Subject: Safety-Kleen Systems, Inc. FLD 980 847 271, Operating Permit No. 34744-HO-007, *Site Assessment Report* dated August 2012

**ATTACHMENT A**  
Safety-Kleen Systems, Inc., Tampa  
*Site Assessment Report* dated August 2012

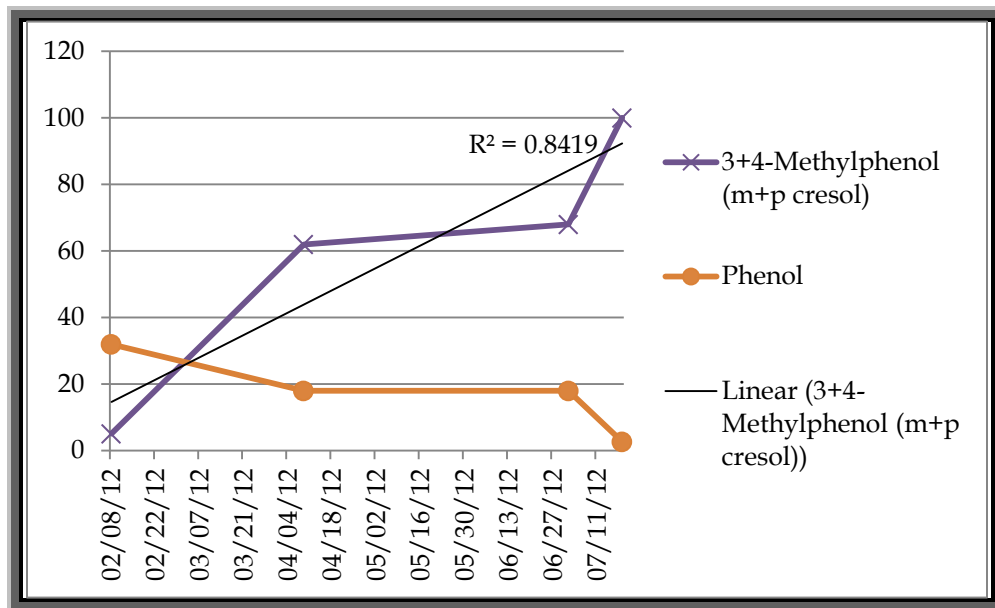
5. (8-3/Section 8.2 Recommendations) In evaluating potential Risk Management Options under rule 62-780.680, F.A.C., RMOII appears to be the most likely option at this point as noted on the top of page 4-3. One of the criteria is to demonstrate that the plume is stable or shrinking. There are insufficient data to make this demonstration at this point (simply due to the few number of sampling events) but the SAR has correctly proposed additional sampling. One area to focus on is MW-2 and the methylphenols. Although the population is small, the data show an increasing trend in 3+4-methylphenol:

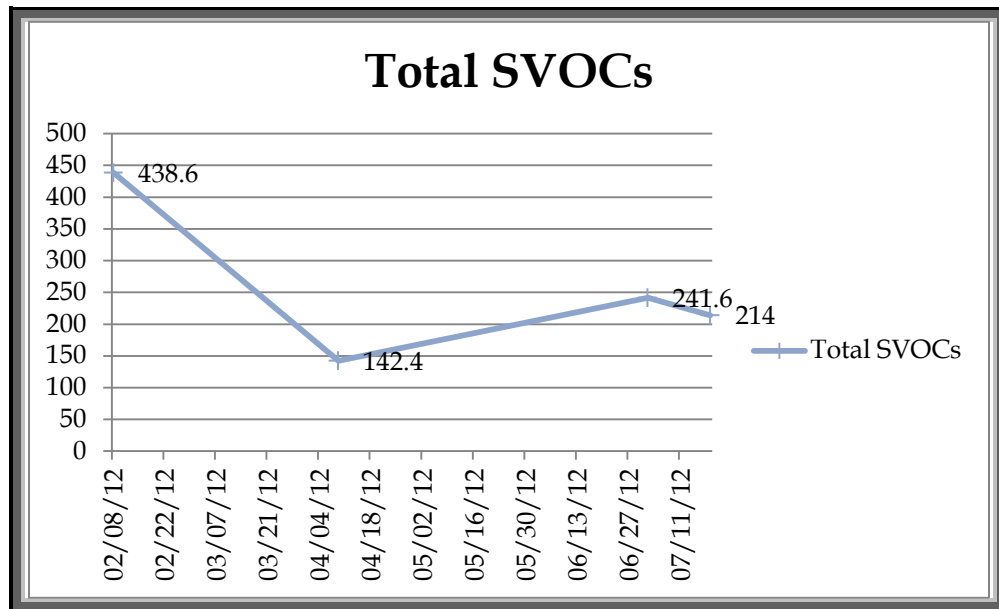
6. (8.2.1 Natural Attenuation Monitoring Plan) The Monitoring Only Plan (MOP) is proposed for releases of organic contaminants from the former septic tank area. One could argue that the increase in 3+4-methylphenol might preclude meeting one criterion for proposing NAM (specifically, paragraph 62-780.690(1)(e), F.A.C.); however, there has been an overall decrease in contamination based upon the total SVOCs. Continued monitoring may reveal otherwise:

Therefore, the MOP is approved pending the following comments or clarifications:

1. As mentioned earlier, the reporting of 3-methylphenol and 4-methylphenol together is acceptable; however, the lower of the two GCTLs must be applied to the combined phenols. More explicitly, the 3.5  $\mu\text{g}/\text{l}$  GCTL for 4-methylphenol would apply to the combined concentrations in this situation [and the Natural Attenuation Default Concentration (NADC) will be 35  $\mu\text{g}/\text{l}$ ].

2. Aside from indicators measured during well purging, SVOCs using Method 8270 should continue to be monitored. Continue to report (summarize in tabular form) all detected constituents as you have done for the SAR. These data may continue to support that overall contamination is decreasing.

3. We concur that a *minimum* of two additional quarters are required. In the event that GCTLs are not met after these two quarters, quarterly monitoring will need to continue until GCTLs are met or to demonstrate that the plume is stable or shrinking as discussed earlier.

4. TPOC wells are not needed for onsite contamination. Wells MW-3 and MW-4 will be considered the point of compliance.
5. We suggest that the annual review discussed at the top of page 5 be done after the January 2013 sampling event. From a practical standpoint, the only ongoing post septic tank cleanout remedial mechanism has been natural attenuation. With the removal of source material in early 2012, it would be appropriate to complete an annual review about a year later.
